Certificate of Appropriateness for 1811 Regent

March 11, 2019

Basement Window

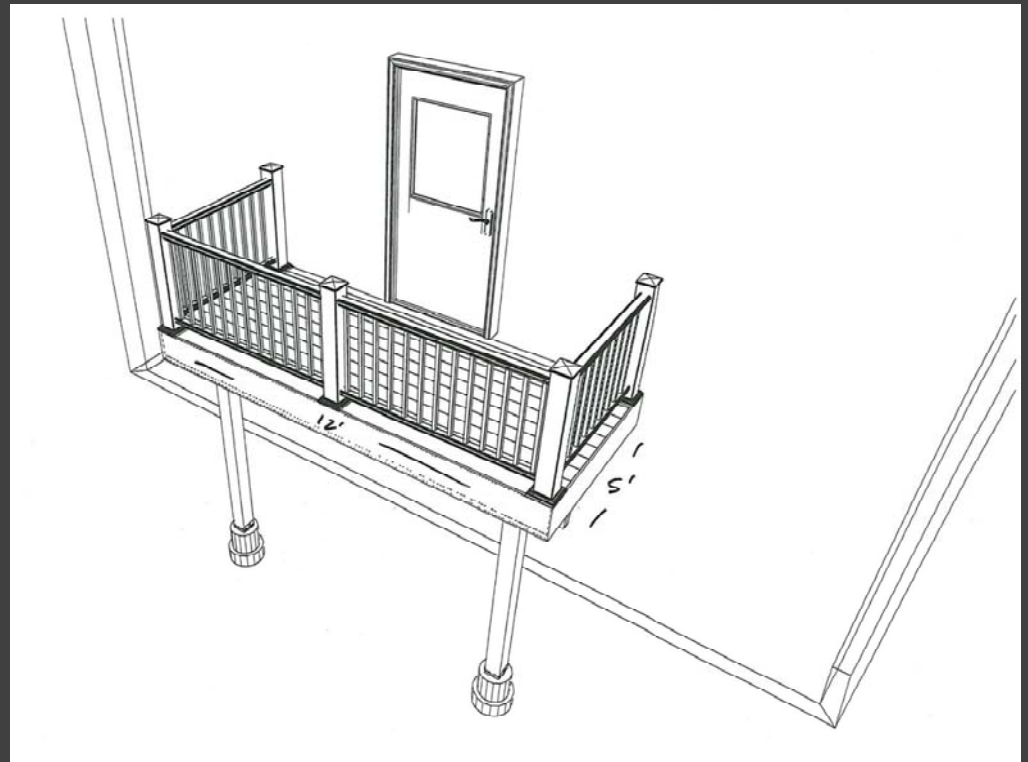
1. Replacement shingle siding must match the existing profile and exposure of the historic shingle siding.
2. The replacement belt band and other trim must be untextured.
3. The replacement basement window must have a three-lite configuration.
4. The balcony must have balusters which replicate the style of the historic balcony; the foundations for the piers cannot be visible above grade; the balcony balusters shall replicate the style of the original; and all replacement materials shall match the trim details of the house.
